HISTORIC AND DESIGN REVIEW COMMISSION March 21, 2018

HDRC CASE NO: 2018-097 808 E CARSON **ADDRESS:** NCB 1266 BLK 2 LOT 2 **LEGAL DESCRIPTION: ZONING:** R-6, H **CITY COUNCIL DIST.:** 2 **DISTRICT:** Government Hill Historic District **APPLICANT:** Pegy Brimhall **OWNER:** 808 E Carson, LLC Construction of two, two story residential structures **TYPE OF WORK:** February 22, 2018 **APPLICATION RECEIVED:** April 23, 2018 **60-DAY REVIEW:**

The applicant is requesting conceptual approval to construct two, two story, multi-family residential structures on the vacant lot at 808 E Carson.

Project Number: 201801 Sheet Contents: Landscape **General Notes** and Schedule Sheet Number: L0.0

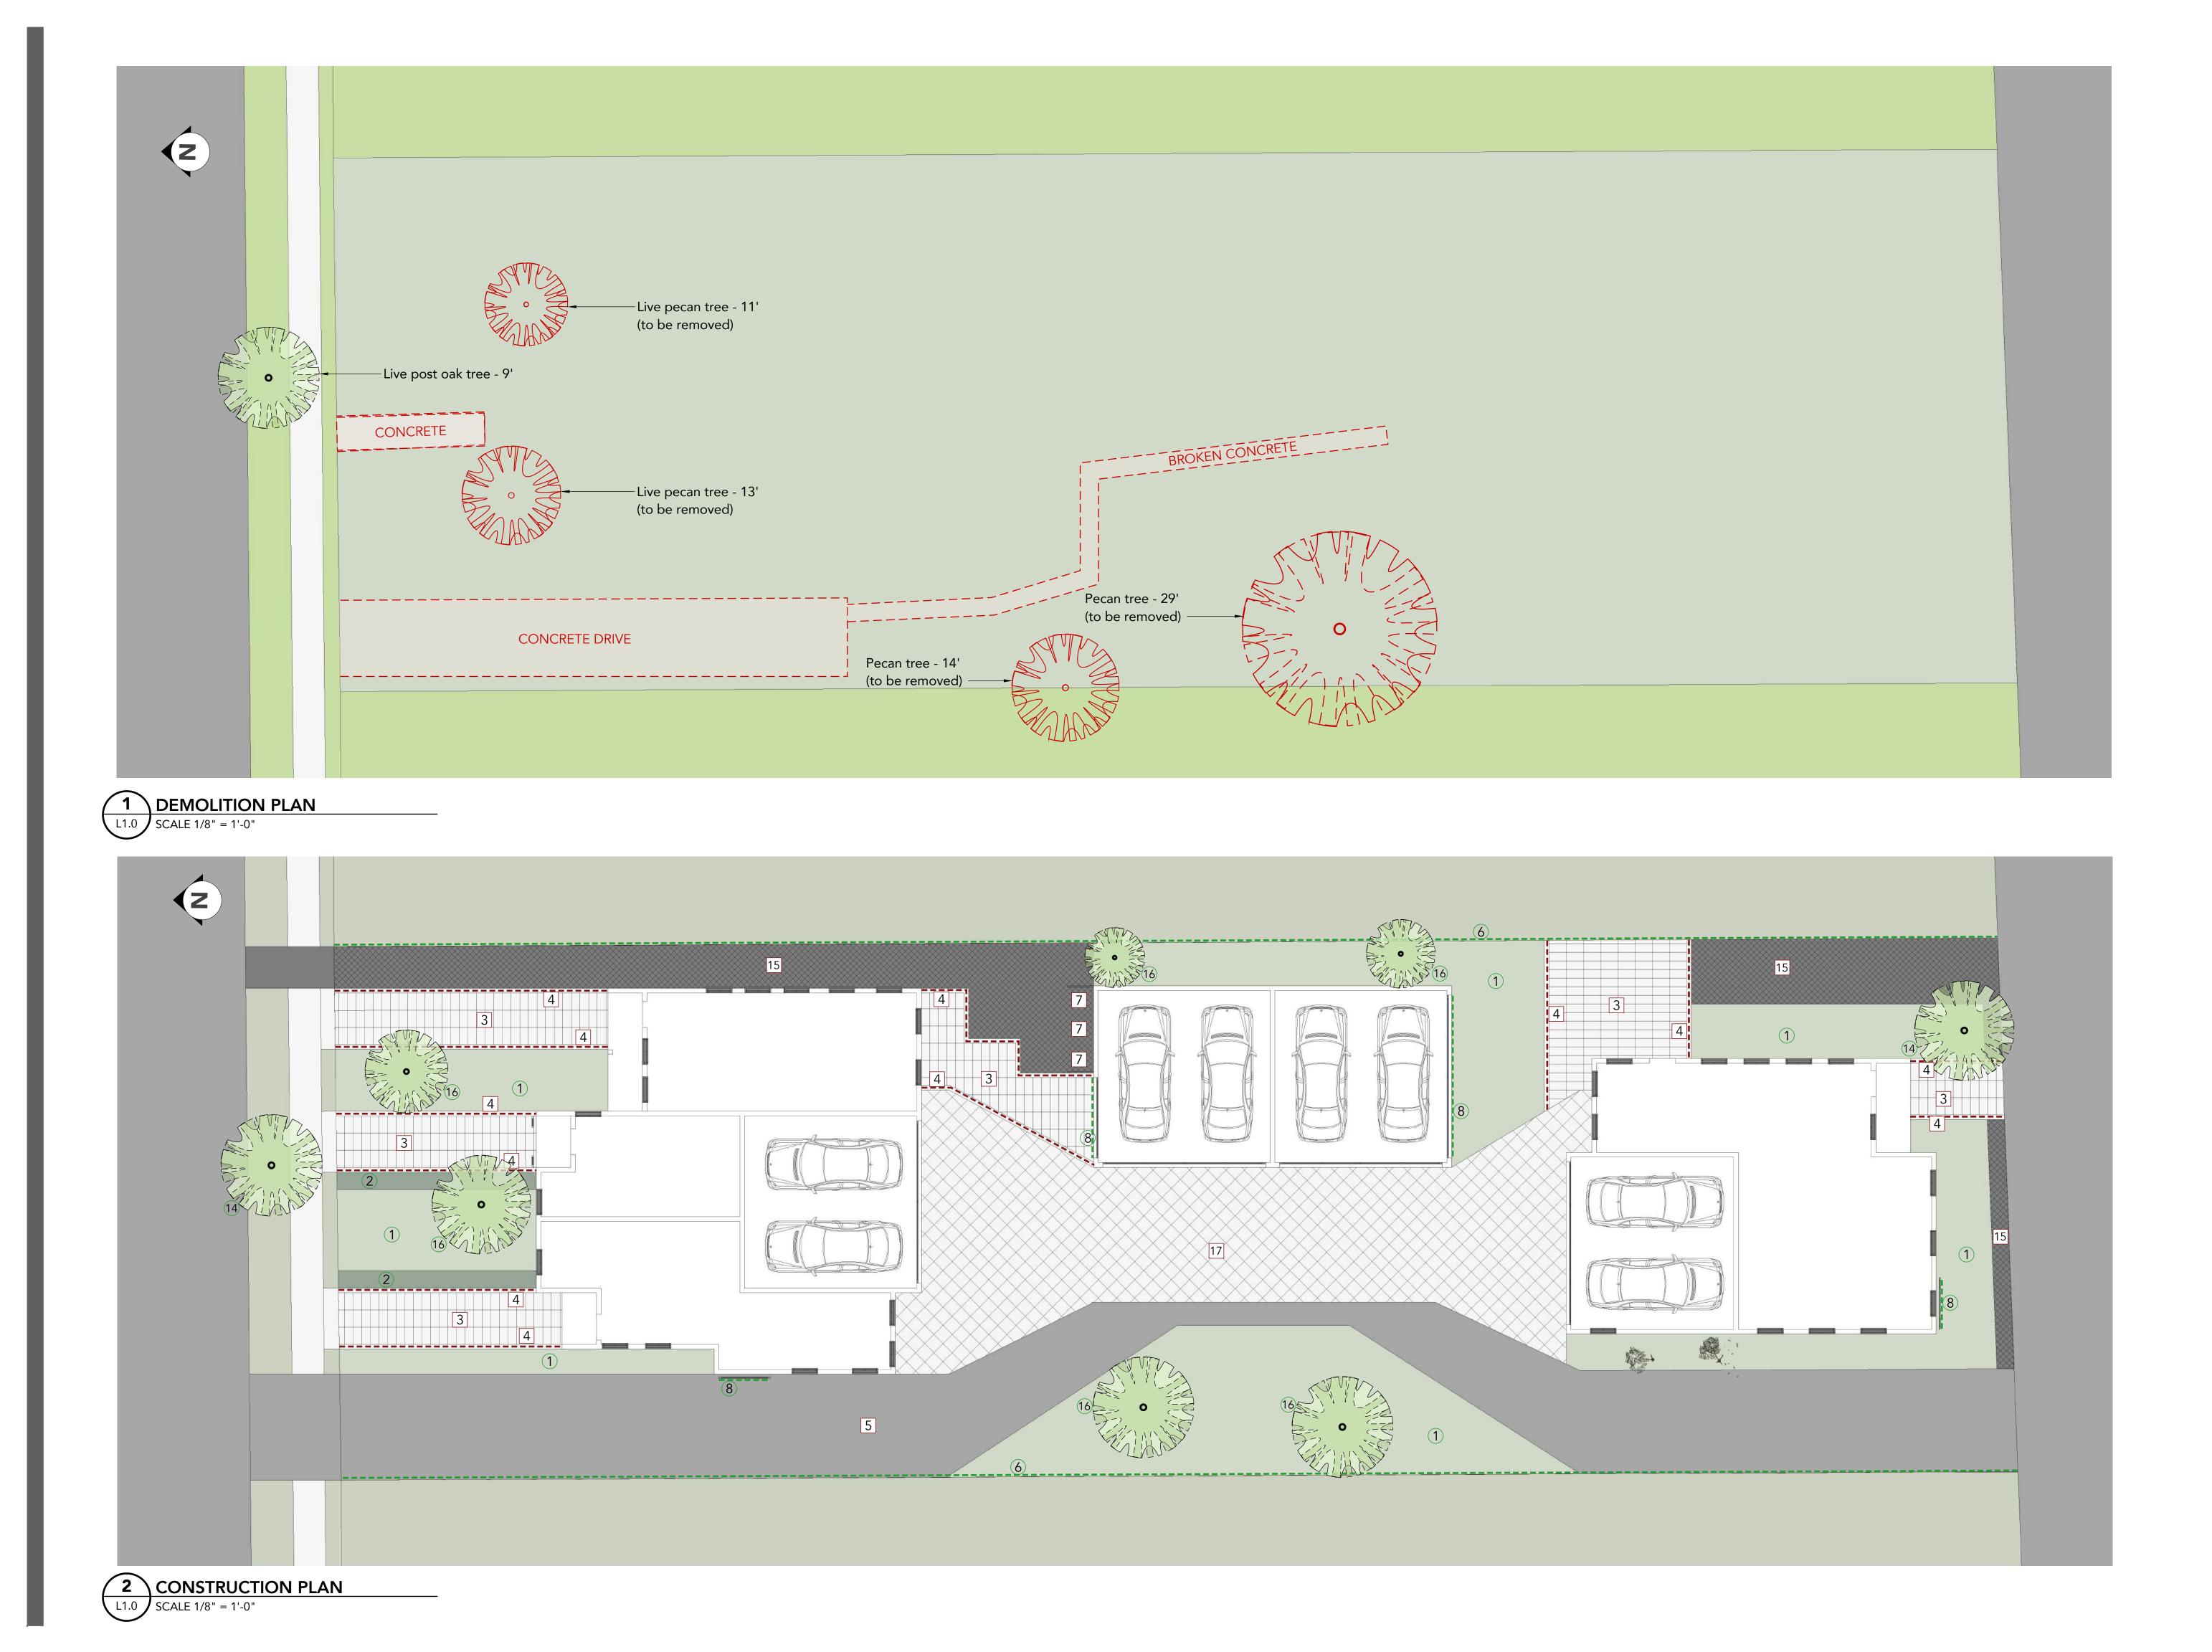
- c. DESIGN REVIEW COMMITTEE This request was reviewed by the Design Review Committee on February 27, 2018, where committee members noted that black gravel was inappropriate, that the proposed massing approach was much improved, that the proposed parking solution is appropriate, that the window profiles are appropriate and that there was no concern over the proposed roof decks.

- q. LANDSCAPING The applicant has provided staff with a landscaping plan that notes proposed materials and their general locations as well as location of site elements. Staff finds the use of black gravel inappropriate. All driveways should feature profiles that match those found within the district including width and materials.
